SUBMISSION ON PROPOSALS FOR DEVELOPMENT OF SKERRIES TOWN PARK

Skerries Cycling Initiative (SCI) makes the following submission in response to Fingal Co. Council's proposed [Skerries Town Park Masterplan](#).

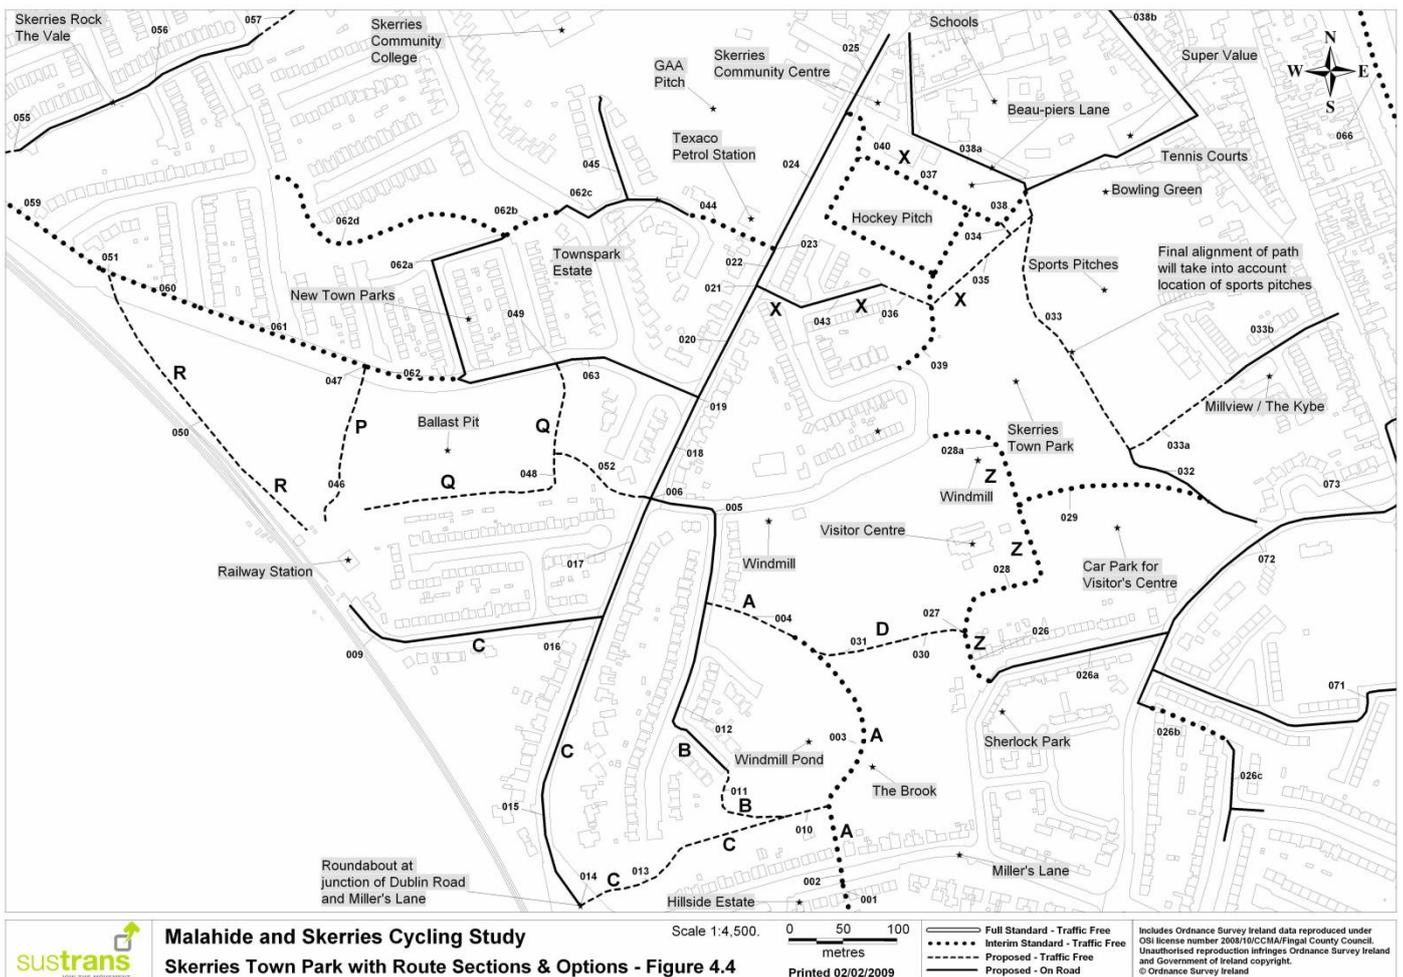
4.3.3 The ideal alignment is that it should link directly with the Southern corner of the tennis pitches – as shown in Figure 4.4 below. The exact alignment, decided upon at the detailed design stage, is subject to the recognition of the use of the pitches and on drainage considerations.

The proposed path is coded "033" in Fig 4.4 below. It is important to understand that walkers and cyclists will take the most direct route available to reach their destinations. Happily, as FCC's Masterplan diagram shows, it is feasible to create this North-South path, especially as the existing pitches are to be re-aligned. If the alignment of the two major pitches, GAA and Soccer pitches, is carefully done, and the alignment of the 7-A-Side pitch and the playground (or as we suggest, the second 7-A-Side pitch) is also slightly changed, one can create a fairly straight tarmacadam path from the Mills car park approximately to the tennis courts. Even if the pitch re-alignment does not permit a direct straight-line path, it will be direct enough to encourage walkers and cyclists to keep on it.
